Access Compliance Report

Public Rights-of-Way

Intersection ID: 7289	Main Street: GLORYLAND_AV	Cross Street: N_TRYON_ST	Location: SE
ADA ID: 4E3562D58E92	Ramp Type: Directional1	Initial Pass/Fail: Fail	Overall Compliance: No
		Severity Score: 12.5

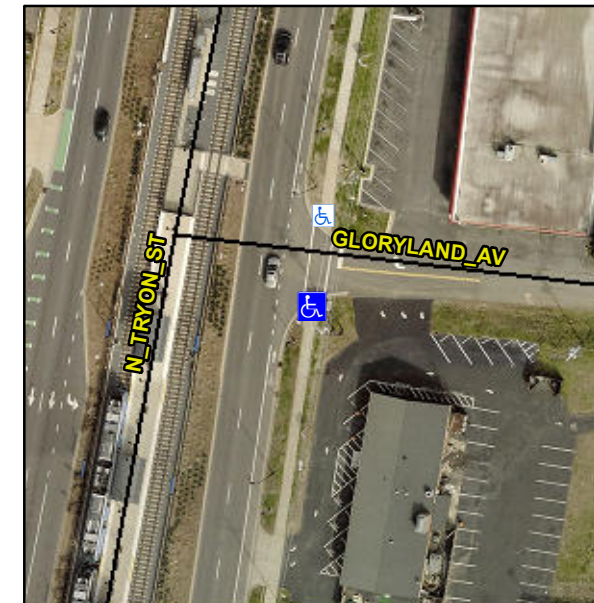
R304.2.2

Compliance	Description	Data	Compliance	Description	Data
N/A	Ramp Length (in)	103.0	N/A	Grade Break?	N/A
Yes	Ramp Width (in)	72.0	N/A	Grade Break Slope (%)	0.0
No	Ramp Slope (%)	8.6	N/A	Grade Break XSlope (%)	0.0
Yes	Ramp XSlope (%)	1.5			
N/A	Flare Type LT	N/A	N/A	Flare Type RT	N/A
N/A	Flare Slope LT (%)	N/A	N/A	Flare Slope RT (%)	0.0
N/A	Flare Traversable LT?	N/A	N/A	Flare Traversable RT?	N/A
N/A	Landing Length (in)	0.0	N/A	DWS Provided?	N/A
N/A	Landing Width (in)	0.0	N/A	DWS Contrast?	N/A
N/A	Landing Slope (%)	0.0	N/A	DWS Length (in)	N/A
N/A	Landing X Slope (%)	0.0	N/A	DWS Full Width?	N/A
N/A	Landing Curb? (Y/N)	N/A	N/A	DWS Offset LT (in)	N/A
N/A	Shared Landing?	N/A	N/A	DWS Offset RT (in)	N/A
N/A	Gutter Ponding?	0.0	N/A	Gutter Slope (%)	N/A
N/A	Gutter Lip Ht (in)	0.0	N/A	Gutter X Slope (%)	N/A
N/A	Painted X Walk1?	Yes		Road Slope (%)	1.0
	X Walk 1 Direction	To N		Road X Slope (%)	2.4
	X Walk 1 Width (in)	116.0		Clear Space?	N/A

Remove & Replace Entire Ramp.
